### PIT6109 Auxiliary Endgate Step Link Contacts Tailgate Paint

#### Models

Brand:	Model:	Model Years:	VIN:		Engine:	Transmissions:
			from	to		
Chevrolet	Silverado	2023 - 2024	All	All	All	All
GMC	Sierra	2023 - 2024	All	All	All	All

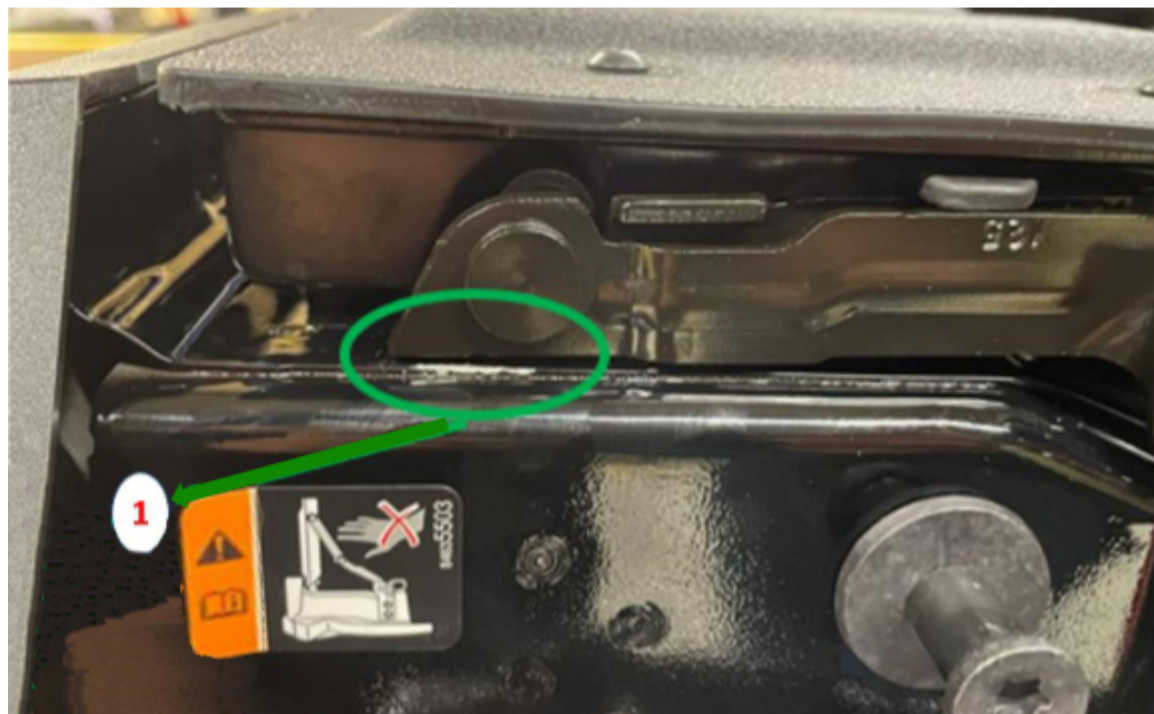
Involved Region or Country	North America
Additional Options (RPO)	QK2 - Multipro / Multiflex Tailgate
Condition	Some customers may comment that the minor / auxiliary endgate step link is contacting the tailgate paint causing a chip in the paint, shown below (1). This condition may occur at either the left and/or right step links.
Cause	The cause of this concern could be build variation in the step link bracket mounting position during assembly.

#### Correction:

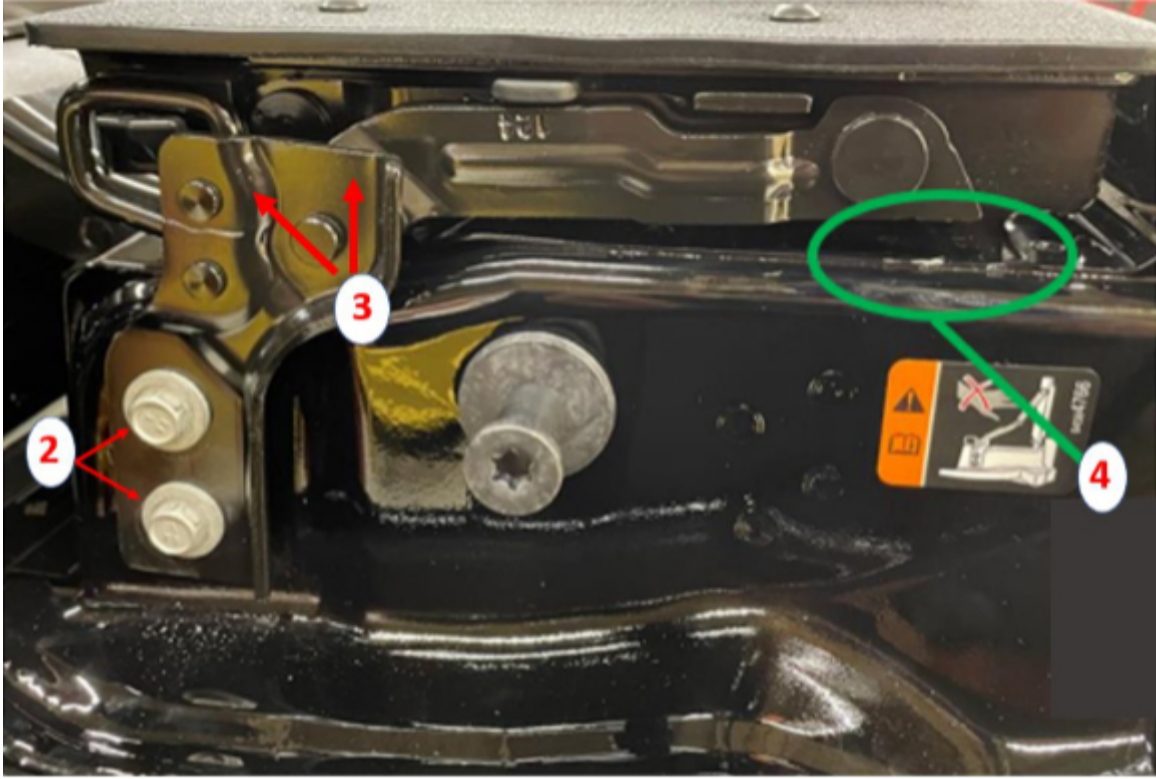
To correct this condition, reposition the step link bracket (3) up and away to slightly lift the step link off the painted surface, shown below (4). Loosen both step link bracket bolts at the left and right sides of the minor tailgate, left side shown below (2). With the step link bracket bolts loose there will be some play in the bracket to allow for repositioning. Starting with the right side step link bracket, lift up on the bracket to achieve and maintain clearance at call out 4 then tighten both mounting bolts (2) to 40 Nm (30 lb. ft). Repeat the procedure for the left side step link bracket. If necessary, a small pry bar can be used to help lift the step link bracket then tighten the bolts (2). There is no need for rust protection where the paint is damaged because the endgate is made from aluminum but touch up paint can be used to fix the paint chip.

If clearance cannot be achieved or maintained after adjustment, please submit a Field Product Report (FPR) with detailed photos per the latest version of bulletin [02-00-89-002W](#).
